Subject: AP1000 Responses to Requests for Additional Information (SRP3)

RAI-SRP3.7.1-SEB1-09 R2

AP1000 TECHNICAL REPORT REVIEW

RAI Response Number: RAI-SRP3.7.1-SEB1-09
Revision: 2

Figure RAI-SRP3.7.1-09-A: FRS nodes at Elevation 289.2'

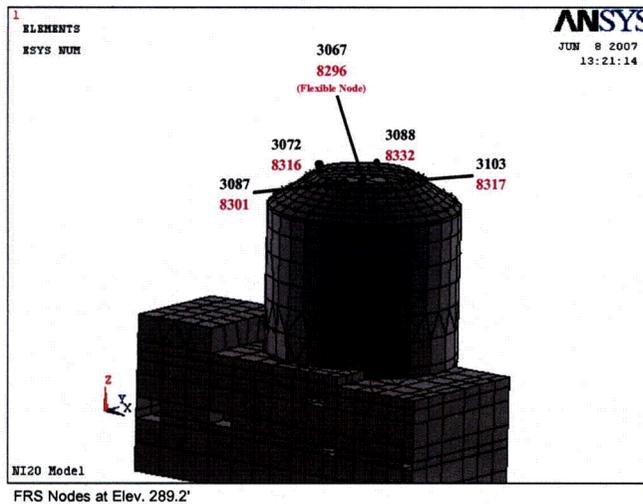
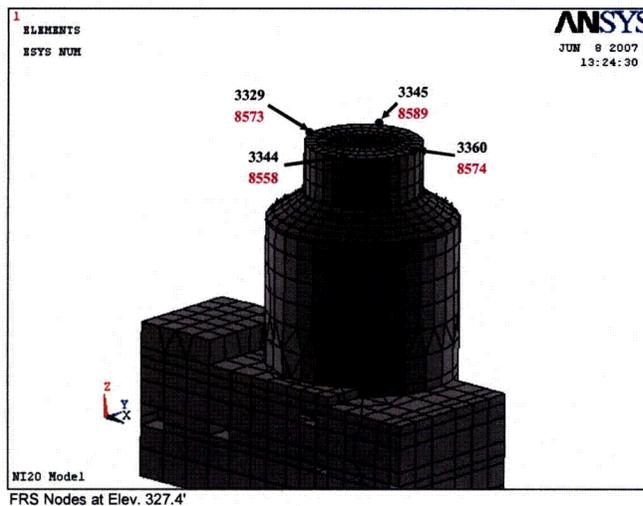
- (e) Considering that the fundamental vertical vibration mode at the top of the shield building (El. 327') is around 6 Hz, it would be expected that the HRHF GMRS may excite a second vertical vibration mode. Figure RAI-SRP3.7.1-SEB1-09-01c: ASB at Elevation 327.4' Z Direction (Node 3345), and Figure RAI-SRP3.7.1-SEB1-10-3: ASB at Elevation 327.4' Z-Direction (Node 3329) do not show this behavior. Figure RAI-SRP3.7.1-SEB1-11-3: Seismic Response Spectra on Roof of Shield Building Z-Direction (Node 3067) does show a second amplified response for the HRHF GMRS at around 14 Hz. Provide a picture depicting the location of Nodes 3345, 3329, and 3067, and provide the technical explanation for the difference in results at these nodes.

- e) Figures RAI-SRP3.7.1-09-A and RAI-SRP3.7.1-09-B show the location of the three nodes 3067, 3329, and 3345. Node 3067 shown in Figure RAI-SRP3.7.1-09-A is at flexible area (response in 14 Hz region) that is not influenced by rocking motion as much as nodes 3329 and 3345.

Figure RAI-SRP3.7.1-09-C: Containment Operating Floor (Elevation 134.25')

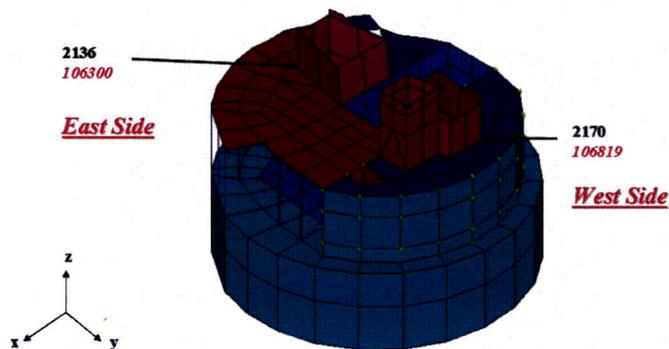
- (g) The staff reviewed the spectral plots in Figures RAI-SRP3.7.1-SEB1-10-4, -5, -6 [Containment Operating Floor, East Side, Elevation 134.25' (Node 2136)], and Figures RAI-SRP3.7.1-SEB1-7, -8, -9 [Containment Operating Floor, West Side, Elevation 134.25' (Node 2170)]. The staff notes that these plots are also contained in TR 115 Rev. 1, Figure 5.2-2. The staff observed that the East Side and West Side y-direction spectra are very similar. However, the East Side and West Side x-direction spectra and the East Side and West Side z-direction spectra are very different, for the HRHF-coherent and HRHF-incoherent cases. The peak spectral accelerations are as follows for the HRHF-coherent and HRHF-incoherent cases:

Location	Direction	HRHF-coherent	HRHF-incoherent
East Side	X	1.6g (20 Hz)	1.05g (20 Hz)
West Side	X	3.5g (13 Hz)	2.8g (13 Hz)

East Side	Y	3.5g (16 Hz)	1.95g (16 Hz)
West Side	Y	3.7g (16 Hz)	2.05g (16 Hz)
East Side	Z	1.9g (40-50 Hz)	0.65g (40-50 Hz)
West Side	Z	3.2g (30 Hz)	1.7g (30 Hz)

The staff cannot determine the reason for this behavior. Provide a detailed technical explanation for these apparently inconsistent results.

- g) Figure RAI-SRP3.7.1-09-C show the location of nodes 2136 and 2170. Node 2170 is surrounded by a large semi-circle IRWST water tank while node 2136 is surrounded by concrete structure floor and steam generator compartment wall. Node 2136 showed more interaction in X and Z direction between the containment internal structures. The responses of both nodes in Y direction are similar because of less structure interaction between the steam generator compartment wall and other concrete structure. The differences between coherent and incoherent responses are justified in b) and c) above.
